Project	IEEE 802.16 Broadband Wireless Access Working Group < http://ieee802.org/16 >	
Title	Comments on MS upstream traffic adjustment	
Date Submitted	2007-09-09	
Source(s)	Kanchei (Ken) Loa, Yi-Hsueh Tsai, Yung-Ting Lee, Hua-Chiang Yin, Shiann-Tsong Sheu, Youn-Tai Lee, Institute for Information Industry 8F, No. 218, Sec. 2, Dunhua S. Rd., Taipei City 106, Taiwan [add other co-authors here]	Voice: +886-2-27399616 Fax: +886-2-23782328 loa@iii.org.tw
Re:	IEEE 802.16j-07/043: "IEEE 802.16 Working Group Working Group Letter Ballot #28"	
Abstract	This contribution proposes to merge the paragraphs in subclauses 6.3.9.16.1, 6.3.10.3.4.1 and 6.3.10.3.4.3.	
Purpose	Text proposal for 802.16j Draft Document.	
Notice	<i>This document does not represent the agreed views of the IEEE 802.16 Working Group or any of its subgroups. It represents only the views of the participants listed in the "Source(s)" field above. It is offered as a basis for discussion. It is not binding on the contributor(s), who reserve(s) the right to add, amend or withdraw material contained herein.</i>

Comments on MS upstream traffic adjustment

In P802.16j/D1, there are many redundancies in paragraphs and diagrams (sequ

Figure ~~108f xxx-a—Unsolicited RNG-RSP triggered by upstream traffic~~ MS upstream transmission adjustment at an uplink-only transparent access-RS

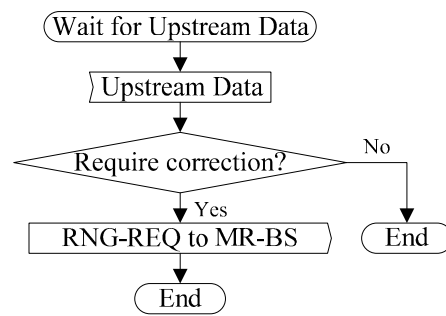
[Move Table 201d, 201g, 201h and Figures 108f, 108g, 108k, 109l to here, and modified as indicated:]
